RE: Invitation to Bid (ITB) 27T05-002 – Custodial Services at multiple Public Housing sites in Juneau, AK

FROM: Andrew Morton, Administrative Services Manager, Procurement

DATE: August 24, 2026

ADDENDUM NO. 1

MT-VIEW FIRST FLOOR REFLECTED CEILING PLAN

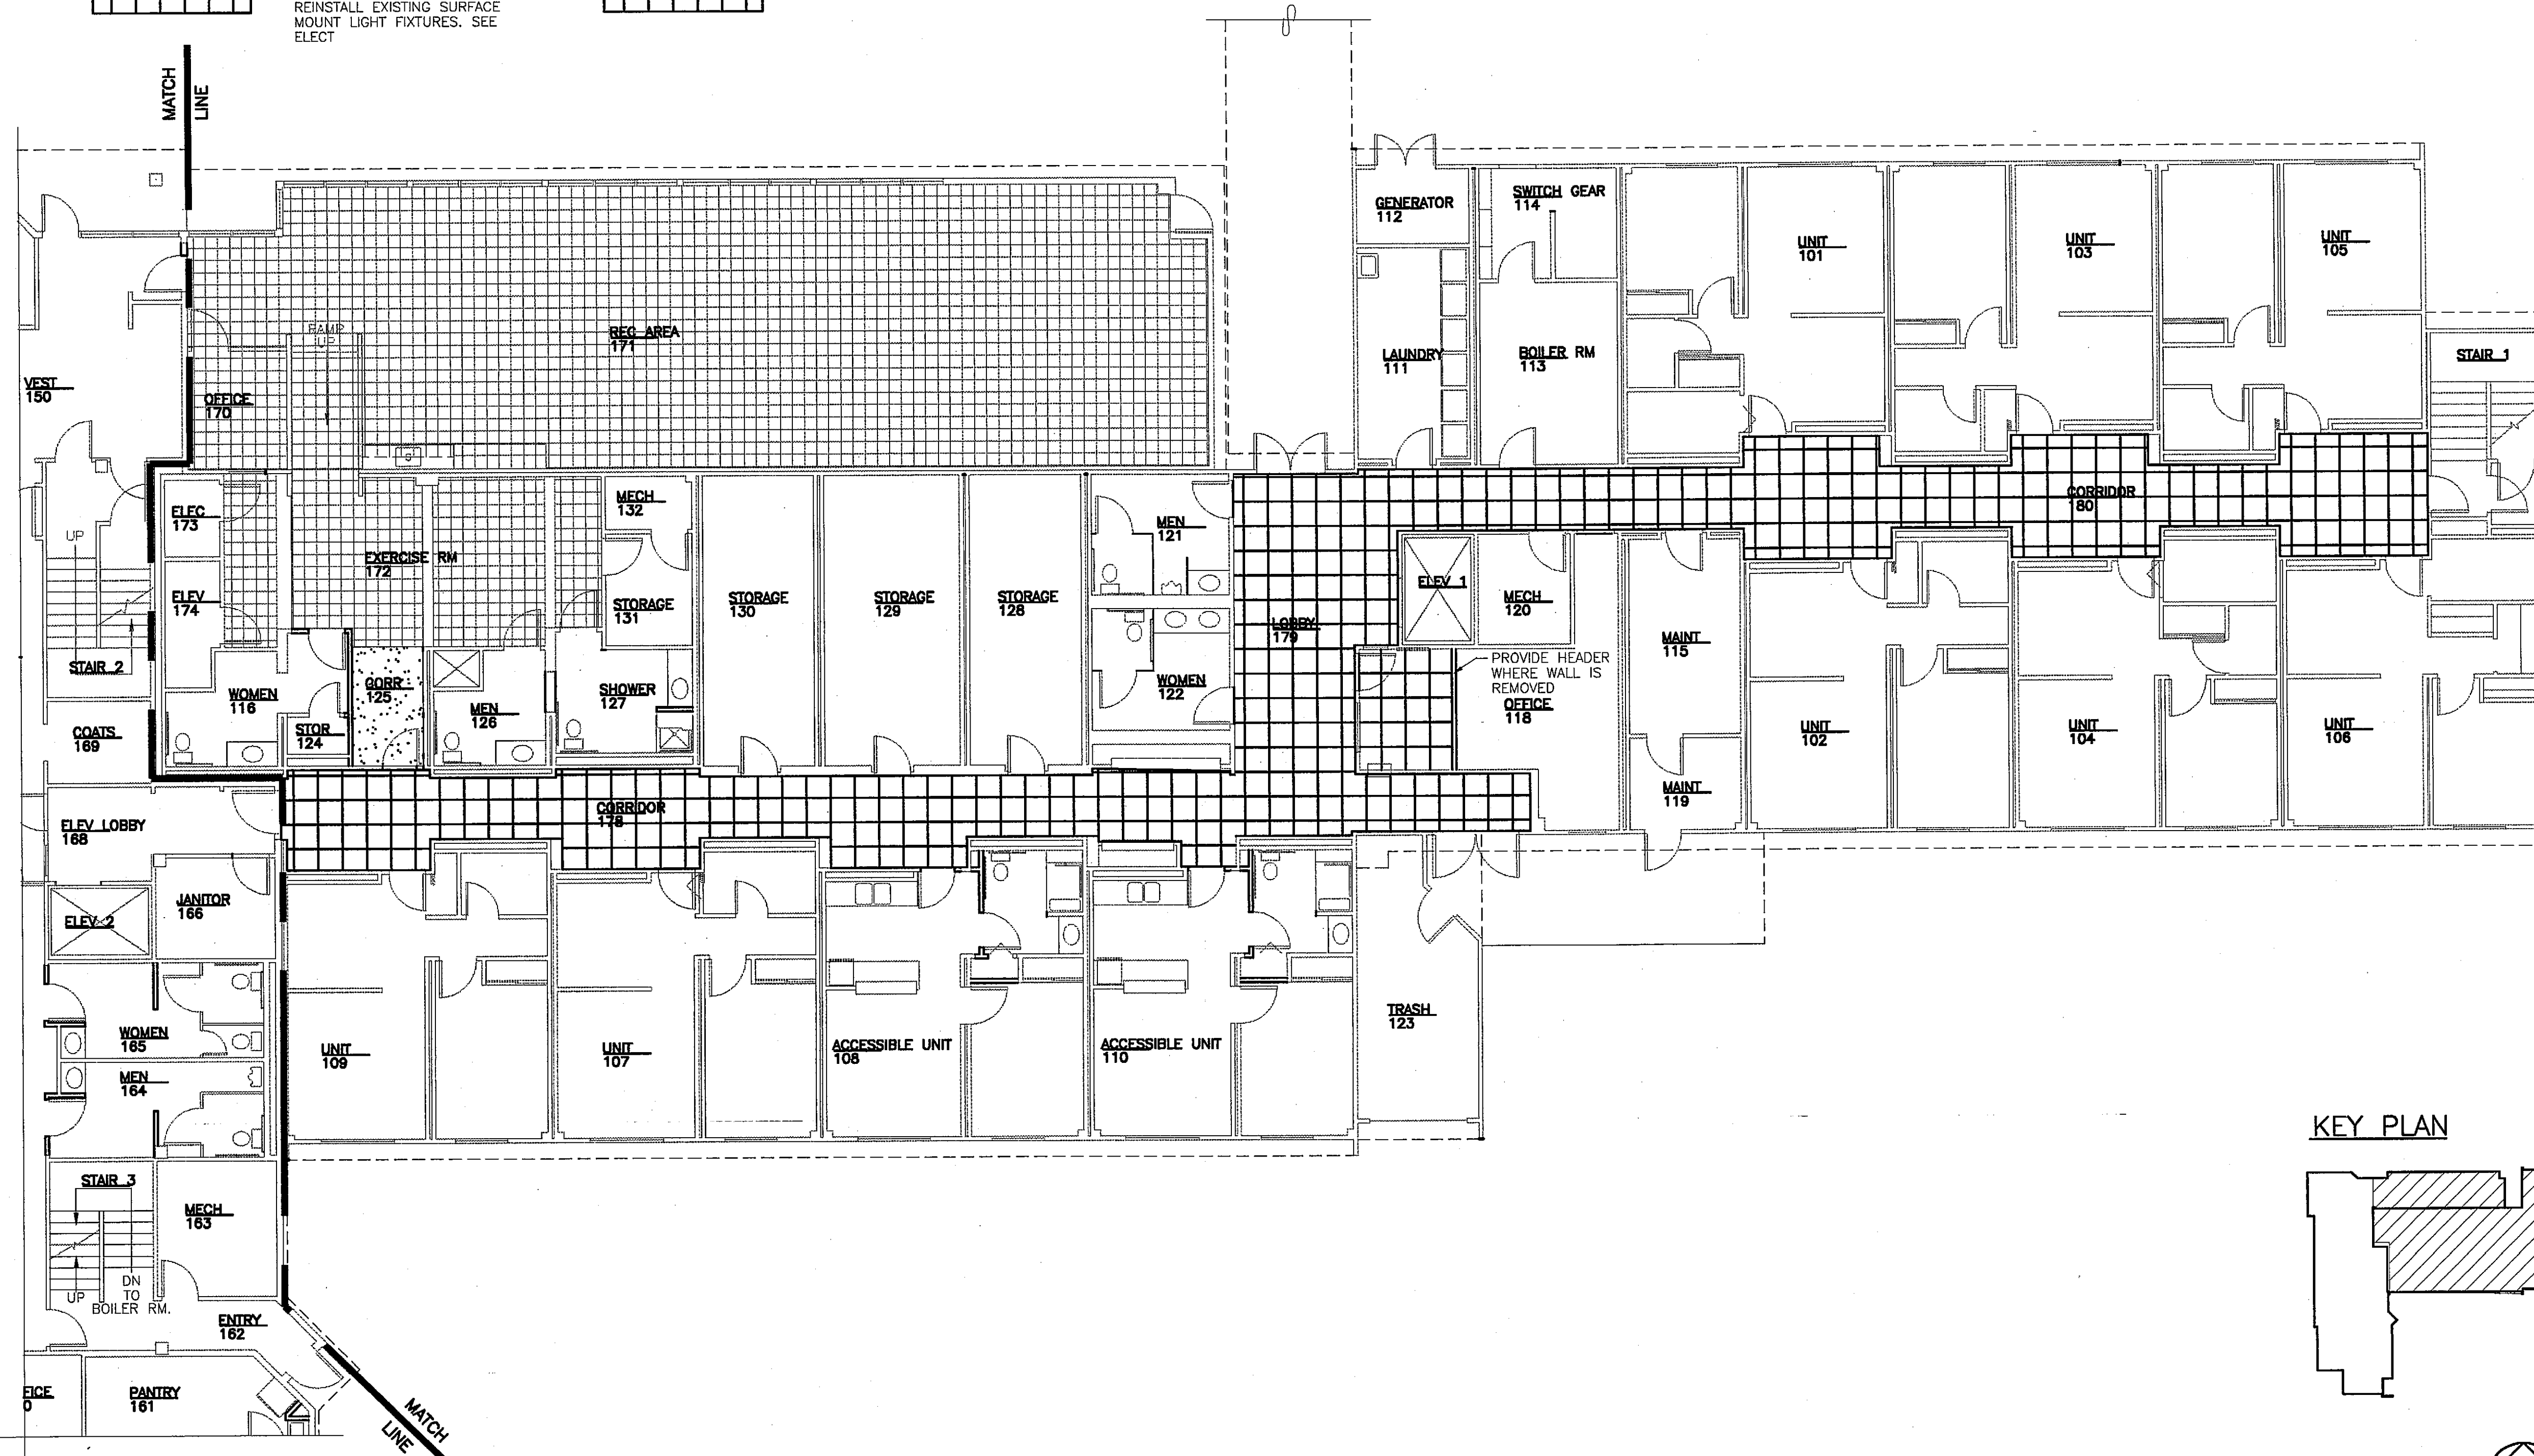
Mountain View	Approximately 4,800 sq ft of floor, either carpet or vinyl flooring. The marked areas are the approximate floor plans that would be vacuumed/cleaned, with the exception of the first floor annex area marked Multipurpose, Dining, and Kitchen. The stairwells will also need cleaned, but are not marked on this floor plan. (attached)
Cedar Park Office, 3410 Foster Avenue	Approximately 2,287 sq ft.
3410 Foster Avenue APT 2	Approximately 1,500 sq ft.
2800 Postal Way Office	Approximately 900 sq ft.
